**RE: Transmittal of Comments (2<sup>nd</sup> Round) on *St. Anthony Mine Site Closure-Closeout Plan (CCOP), 30% Design Report, United Nuclear Corporation/GE, St. Anthony Mine, Cibola County, New Mexico, Permit Tracking No. MK006RE***

SUBJECT: **Request for Comments, St. Anthony Mine, 30% Closure/Closeout Plan Response to Comments, United Nuclear Corporation, St. Anthony Mine, Cibola County, New Mexico Mining Act Permit No. MK006RE**

Subject: **NMED Comments, Response to Comments, 30% Closure/Closeout Plan (CCOP), St. Anthony Mine, United Nuclear Corporation, McKinley County, New Mexico Mining Act Permit No. MK006RE**

Subject: **NMED Comments, Supplemental Submittals, 30% Closure/Closeout Plan (CCOP), St. Anthony Mine, United Nuclear Corporation, McKinley County, New Mexico Mining Act Permit No. MK006RE**

# Attachment to 2/2/24 Letter

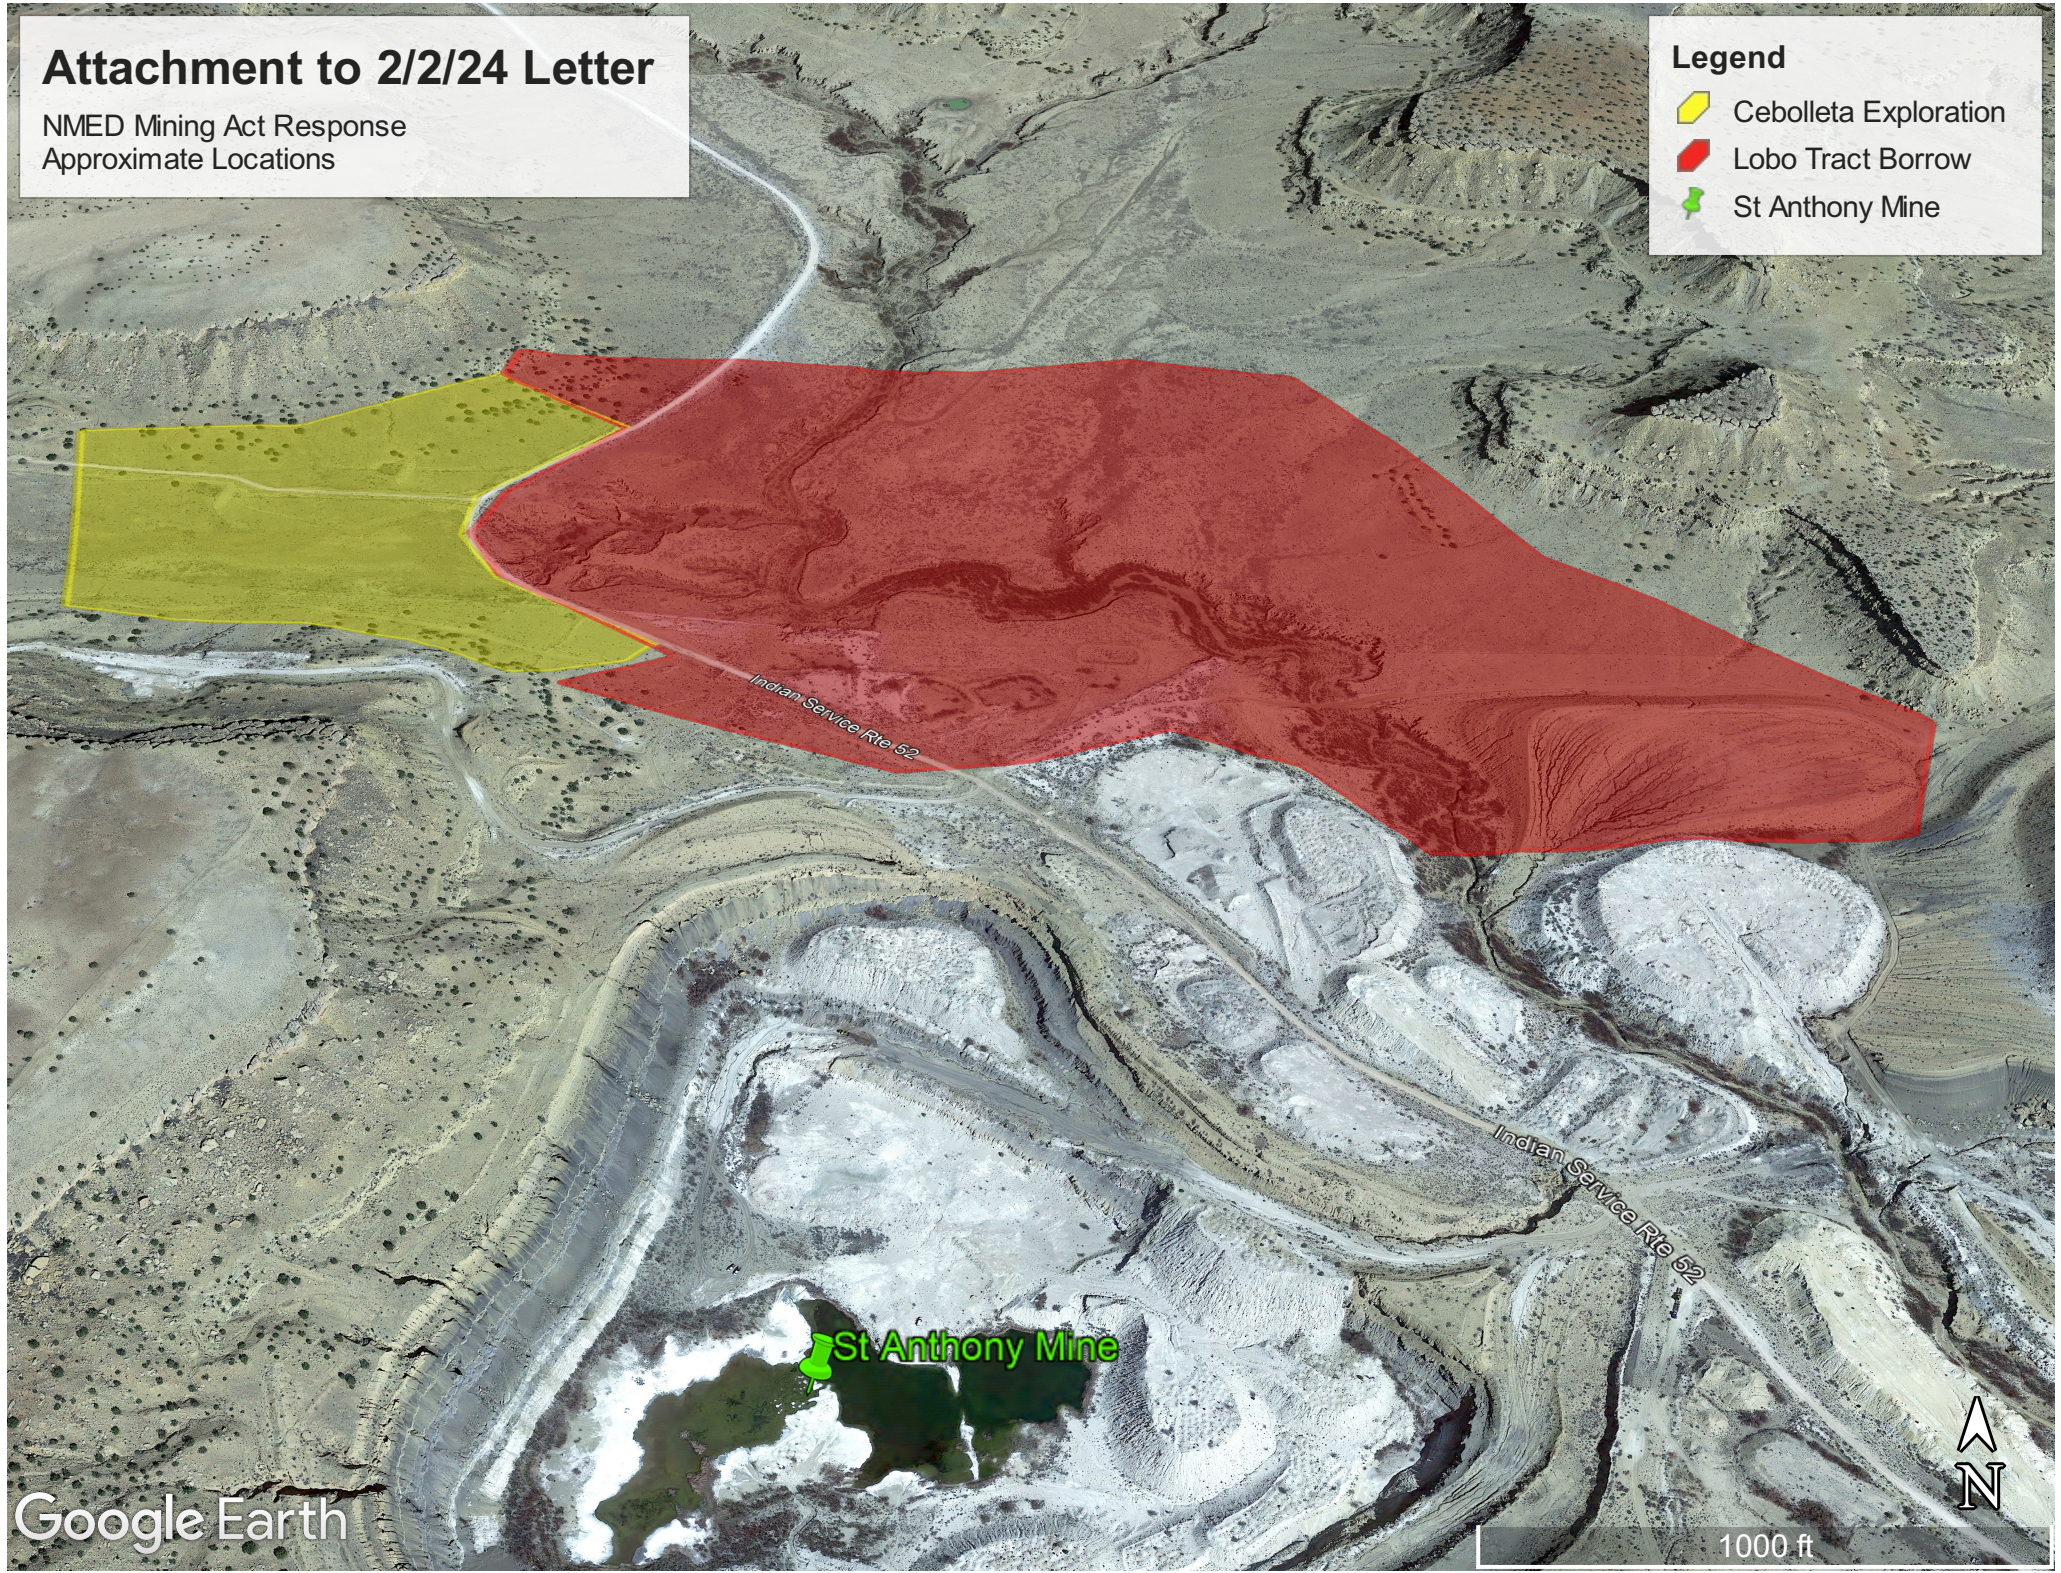
4. *Table 2 Growth Media Borrow Source Summary* – At a site visit on January 17, 2024, it came to NMED’s attention that the Lobo Tract Borrow area overlaps with the area for the Cebolleta Exploration Project (see Attachment 1 for approximate locations based on NMED’s current understanding). Please provide documentation of the agreements between UNC and the Cebolleta Land Grant which enables the use of the Lobo Tract Area for borrow material, while the same area is currently being explored by another company holding the mineral rights.
